# 1997 - 1999: Service Bulletin: Engine Low Coolant Light Comes On (Inspect Rad. Surge Tank, Replace/Reposition)

**Subject:** Engine Low Coolant Light Comes On At Start-Up (Inspect for 2nd Design Radiator Surge Tank and Replace/Reposition)

**Number:** 99-06-02-016

**Models:** 1997-1999 Chevrolet Corvette (1997 Models Built Prior to VIN Breakpoint V5104277)

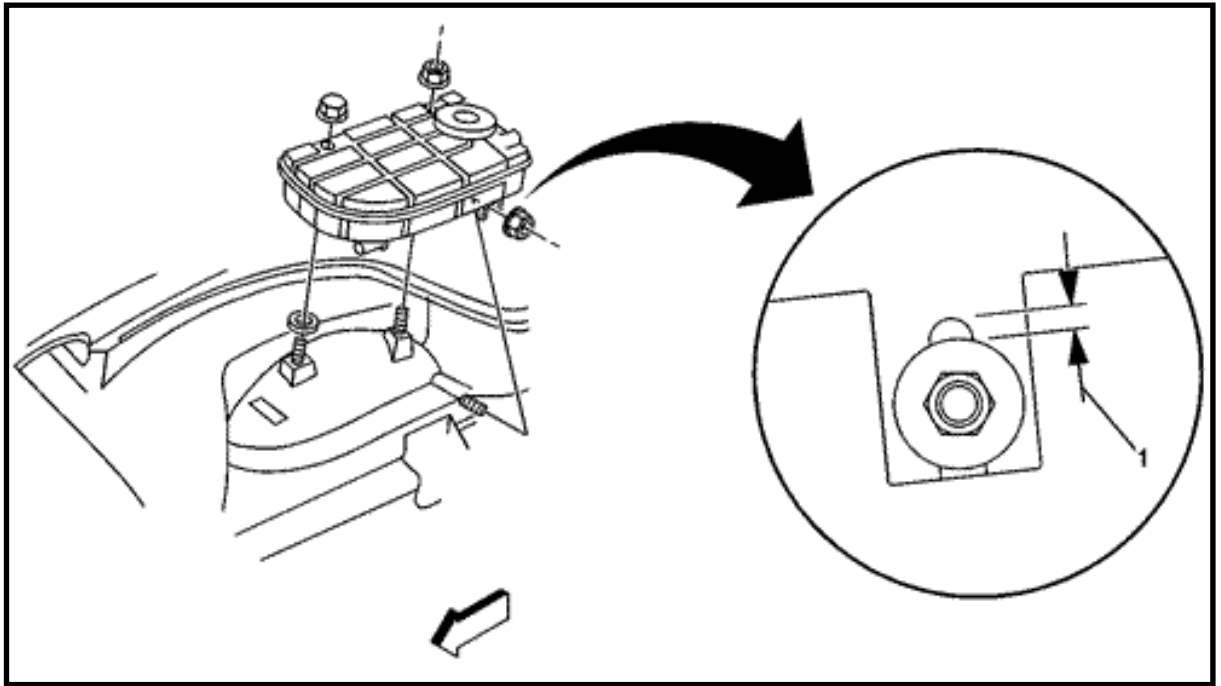
**Cause:** This condition may be caused due to the low coolant sensor being mounted in the rear of the radiator surge tank. When the vehicle is parked with the front lower than the rear, the coolant settles in the front half of the surge tank and with the switch in the rear of the tank, the switch float may be low enough to trigger the light. The "low coolant" light may come on if:

1. For 1997 vehicles built prior to VIN breakpoint V5104277, replace the radiator surge tank and inspect for an out of position wiring harness under the tank. To repair the harness, position the harness downward and secure with a tie strap. To determine if the surge tank is of the first or second design, inspect the low coolant switch cavity in the surge tank. If the surge tank cavity extends 16 mm (5/8 in) below the bottom of the surge tank, the tank is of a second design tank. If the cavity is less than 15 mm (19/32 in) replace the tank with P/N 10405218.

2. For all vehicles, check the level of the tank by viewing the lower mount on the tank. Less than 2 mm (.08 in) (#1) of the mounting slot should be visible above the attaching nut. If the gap is greater than 2 mm (0.08 in), loosen the surge tank and hold in a downward position to achieve less than a 2 mm (0.08 in) gap above the attaching nut. Tighten the bottom nut first, then both top nuts. **Tighten**
